SUBJECT: Duke Energy Corporation
Oconee Nuclear Station, Unit 3, Docket Nos. 50-287
McGuire Nuclear Station, Unit 2, Docket No. 50-370
Catawba Nuclear Station, Units 1 & 2, Docket Nos. 50-413, 50-414

Response to Request for Additional Information
Relief Request 04-GO-002
(TAC NOS. MC3804, MC3805, MC3807, MC3810)

Catawba Unit 2 Reactor Pressure Vessel
Flange-to-Upper Shell Weld

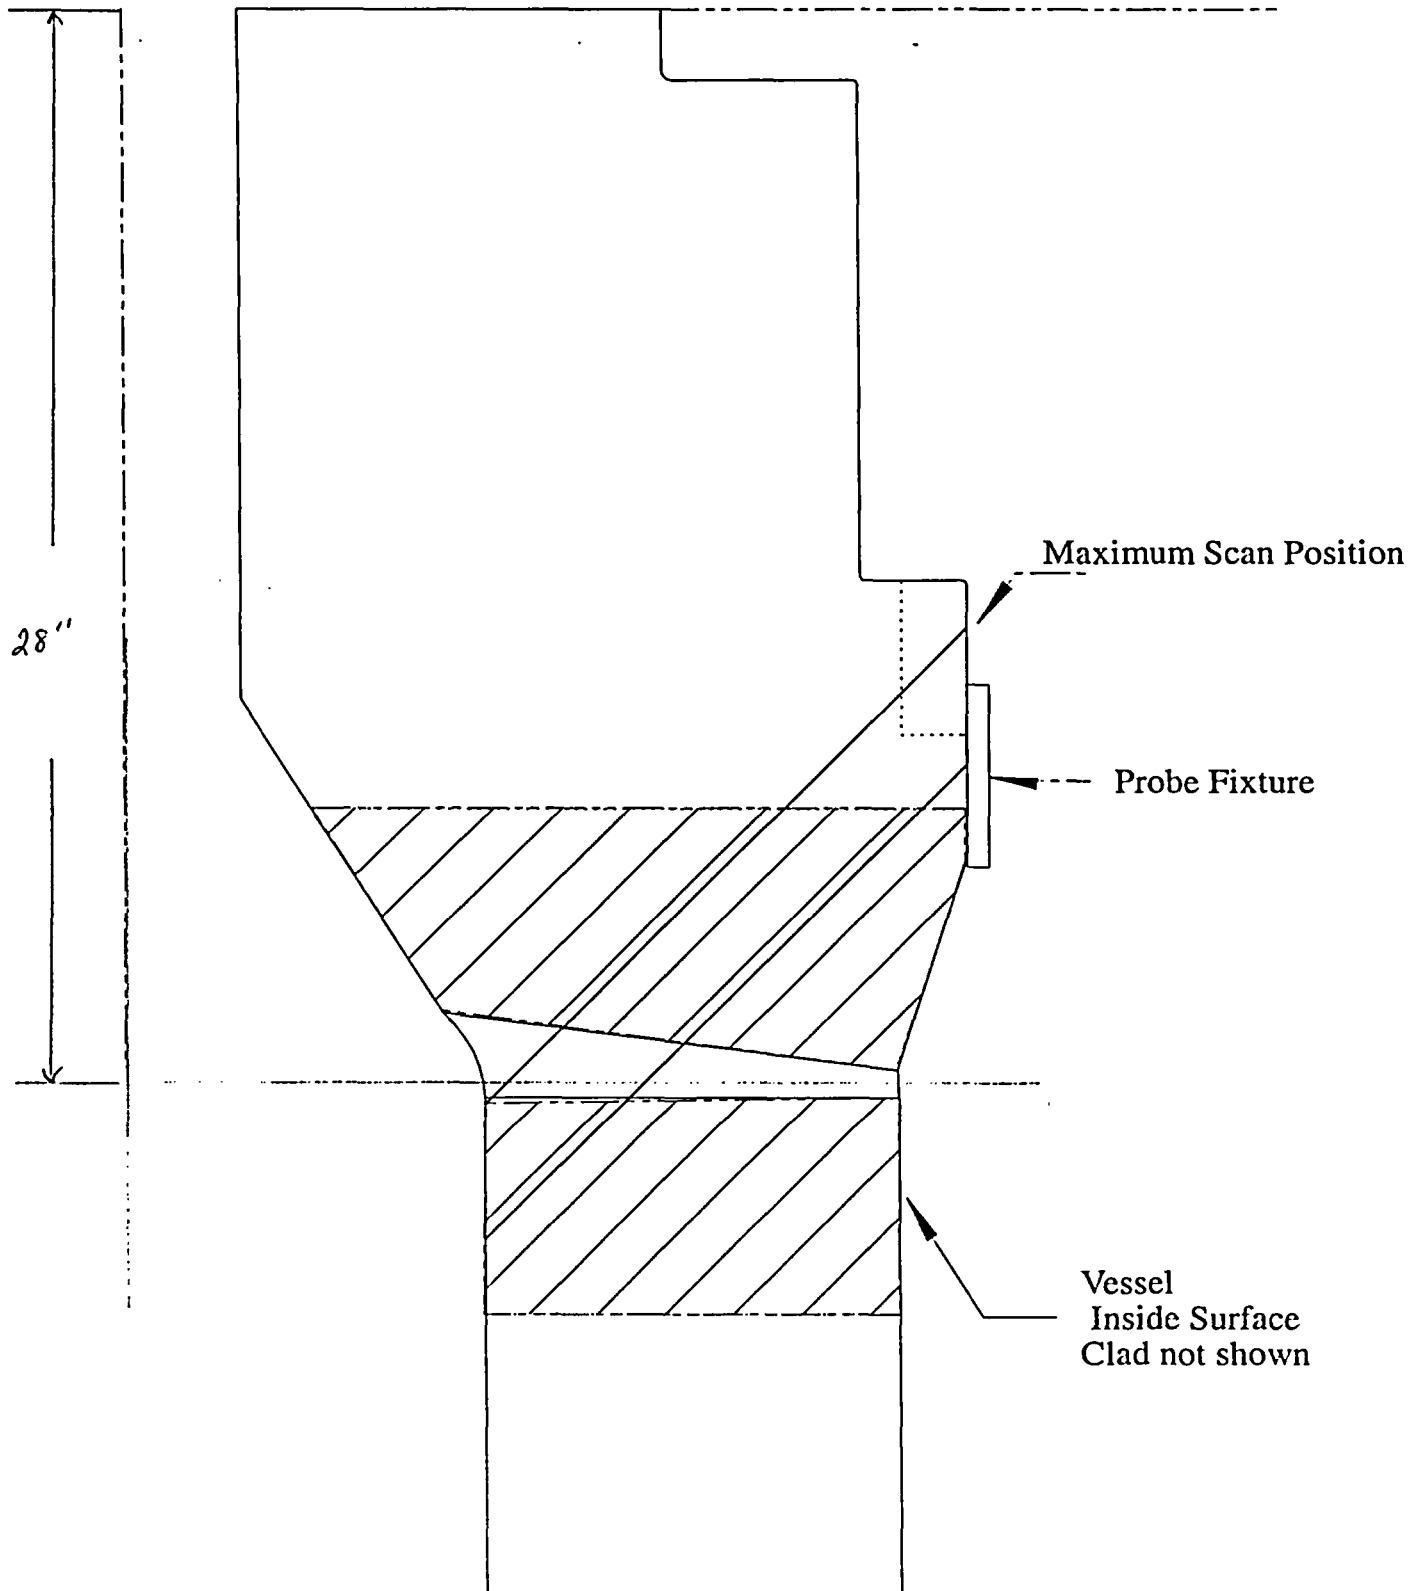
- a. Catawba Unit 2 = 90.5%
 - b. McGuire Unit 2 and Catawba Unit 1 = 90.5%
 - c. Oconee Unit 3 = 72.6%
3. Provide drawings of the RPV Upper Shell to Flange and its weld for the affected units.

Drawings showing the Flange-to-Upper Shell Welds at each unit are attached as follows: Attachment 1, Catawba Unit 2 Reactor Pressure Vessel Flange-to-Upper Shell Weld, Attachment 2, CNS-1, MNS-2 Flange-to-Upper Shell Weld and Attachment 3, Oconee Unit 3 Reactor Pressure Vessel Flange-to-Upper Shell Weld.
